RE: BAIADA INTEGRATED POULTRY PROCESSING FACILITY (SSD 9394) – SUPPLEMENTARY RESPONSE TO SUBMISSIONS

We are writing with respect to SSD 9394 for the Integrated Poultry Processing Plant at 1154 Gunnedah Road, Westdale. As you are aware, since the initial response to submissions was submitted on 3 July 2020, the Applicant has received additional submissions from various agencies and departments via DPIE. These matters have been raised and addressed in separate responses.

As requested, this correspondence has been prepared to provide a consolidate all the supplementary responses to submission and an updated set of development plans within a single document.

**MARK UP ONLY
NOT FOR CONSTRUCTION**

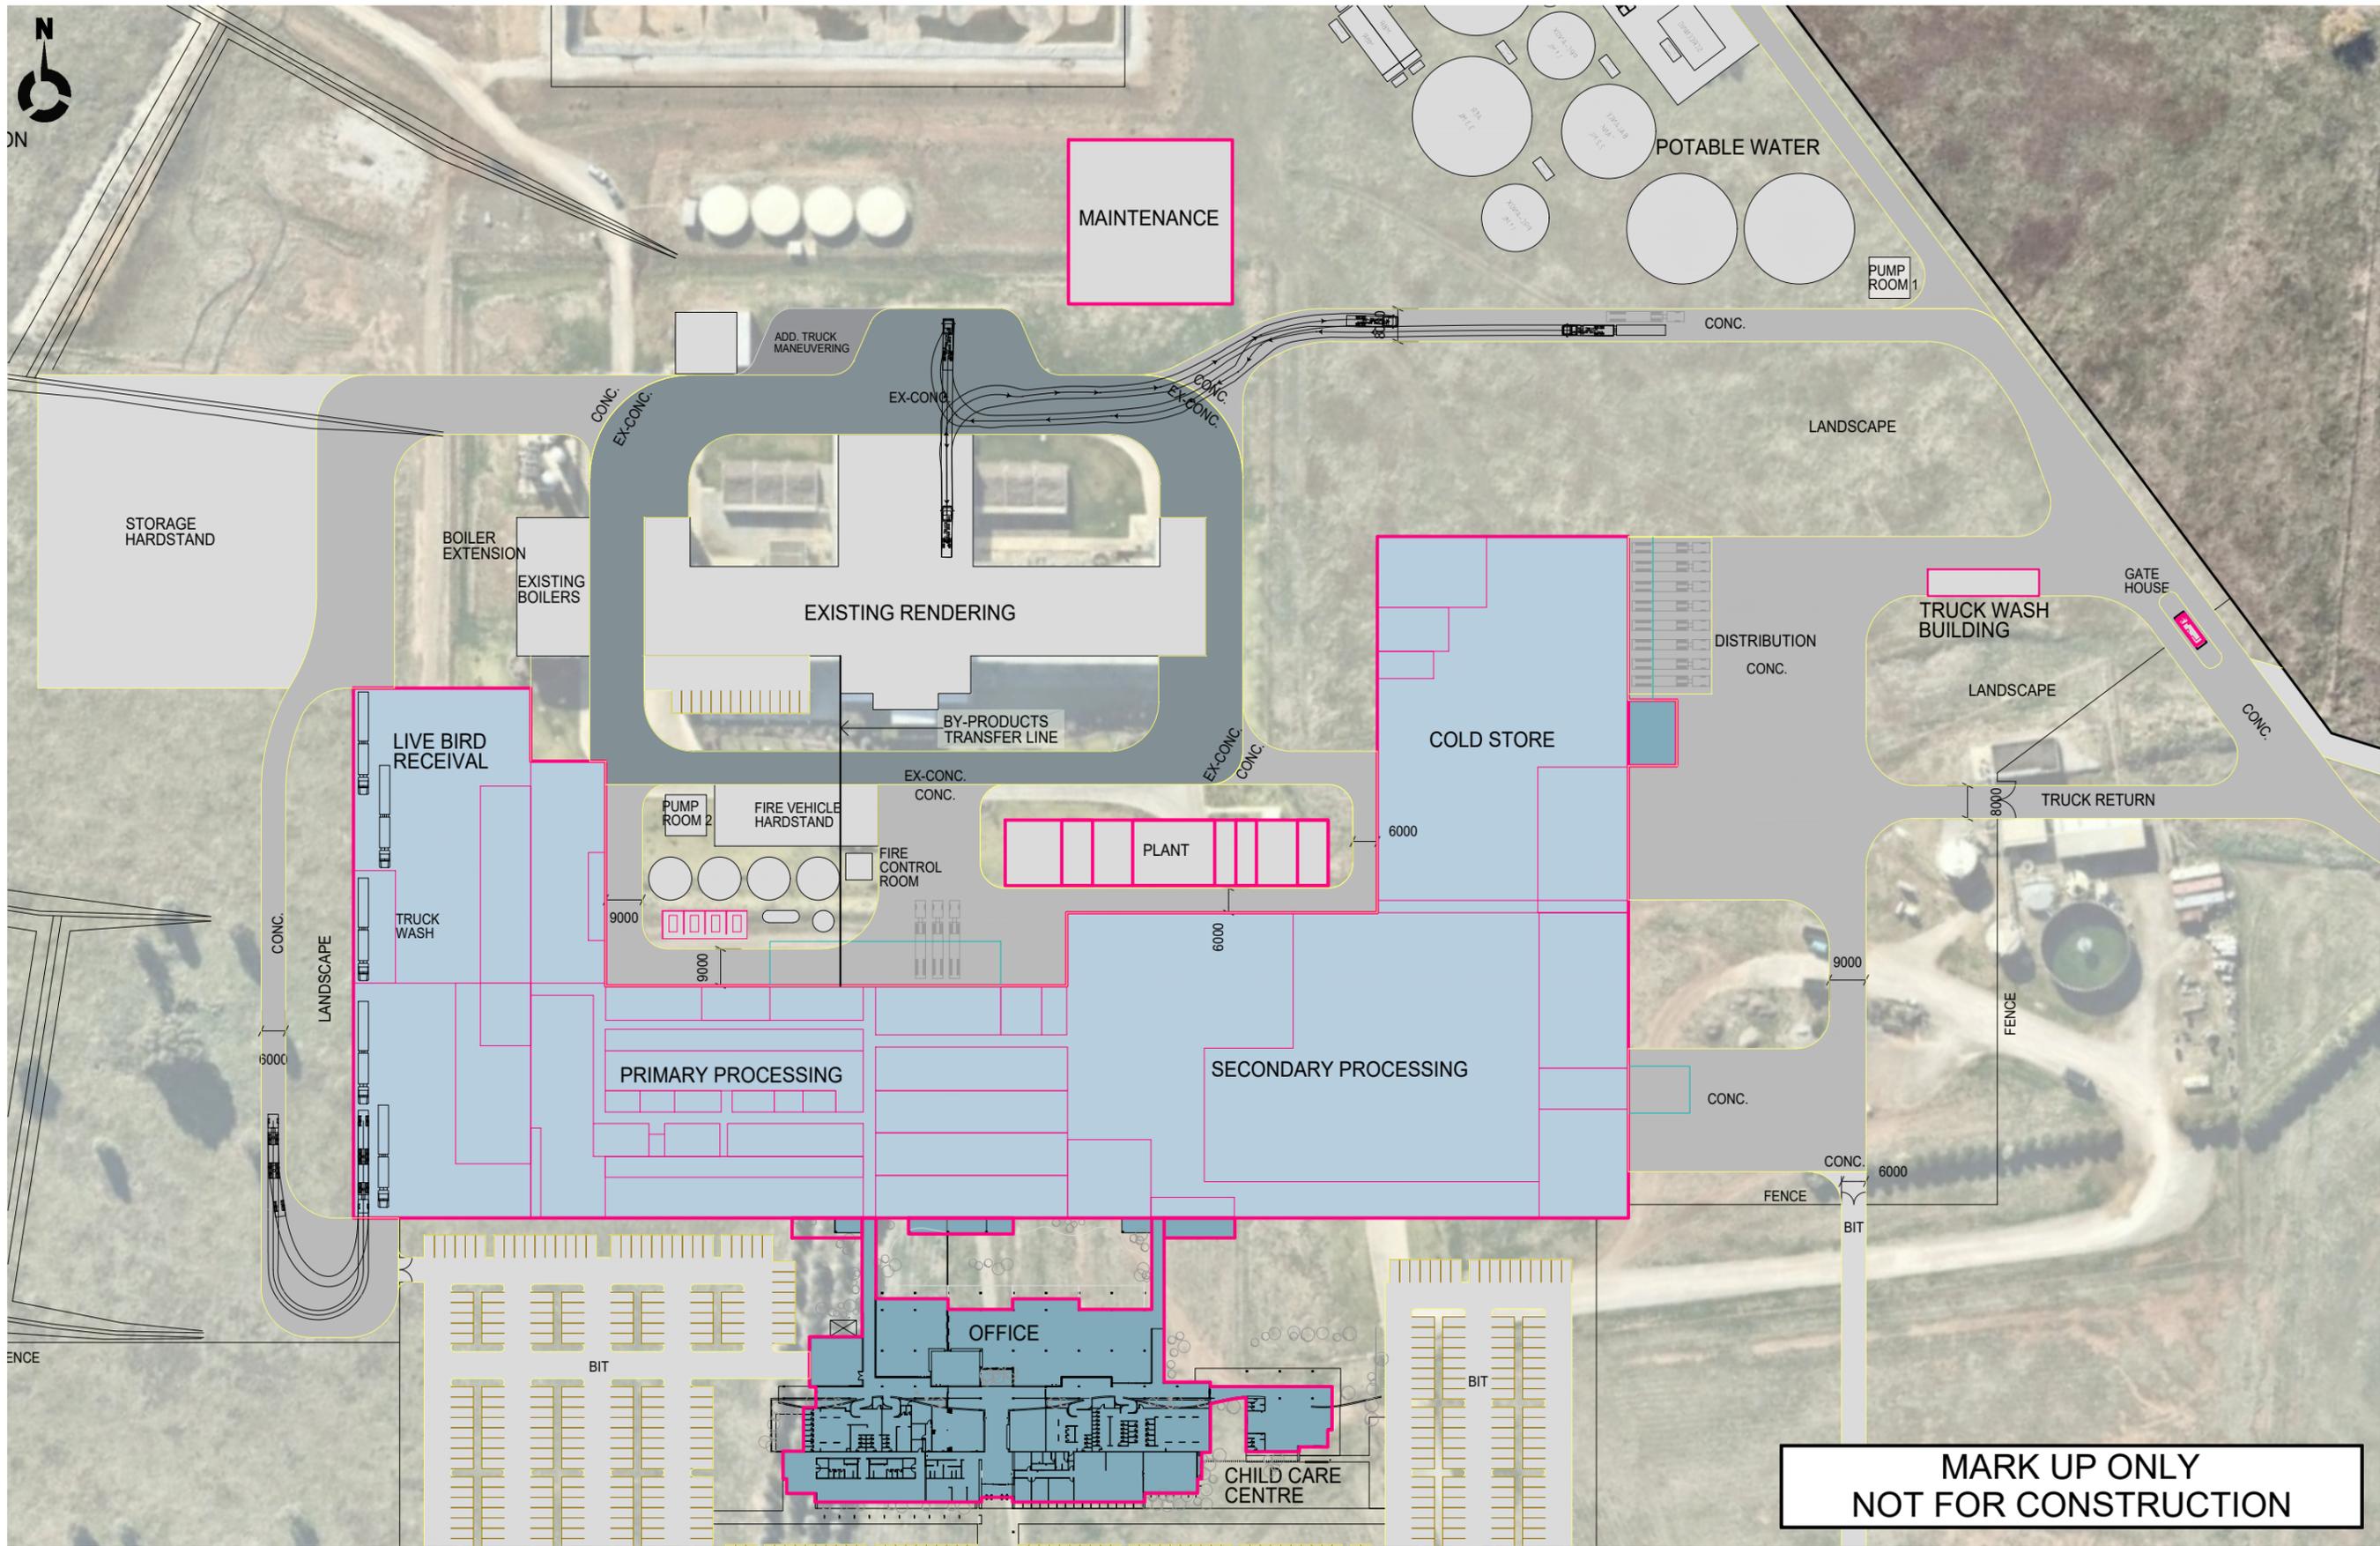
<ul style="list-style-type: none"> <i>The receipt and dispatch areas for rendering raw materials and finished rendered products appear unclear in the site plan. This should include swept path analysis of the largest vehicle (it is unclear whether a B-Double or a large rigid will be used as noted previously).</i> 	<p>Additional plans showing the swept paths as requested are provided as Attachment 1.</p> <p>The plans show the following activities:</p> <p>Live Birds: incoming and outgoing B-Double Trucks delivering birds to the live bird shed, parking in the marshalling area, and existing the site.</p> <p>Rendering Plant: incoming trucks (small rigid and semi-trailers) bringing material to the site for</p>

MATTERS RAISED	APPLICANT'S RESPONSE
	<p>rendering. Please note that all by-products from the new processing plant will be pumped via pipelines to the rendering plant, negating a large majority of the incoming trips with fresh material to be rendered on-site.</p> <p>Rendering Plant: B-Doubles collecting finished rendered products for transport off site.</p>
<ul style="list-style-type: none"> • <i>Identification of the truck marshalling area for both inbound and outbound trucks should be shown in the site plan. So that traffic flow can be safely and efficiently managed.</i> 	<p>Additional plans showing the B-Double swept paths are provided as Attachment 1.</p>
<p>2. TfNSW highlights that in determining the application under the Environmental Planning and Assessment Act 1979, it is the Consent Authority's responsibility to consider the environmental impacts of any roadworks which are ancillary to the development. This includes any works which form part of the proposal and/or any works which are deemed necessary to include as requirements in the conditions of project approval.</p>	<p>Noted.</p>
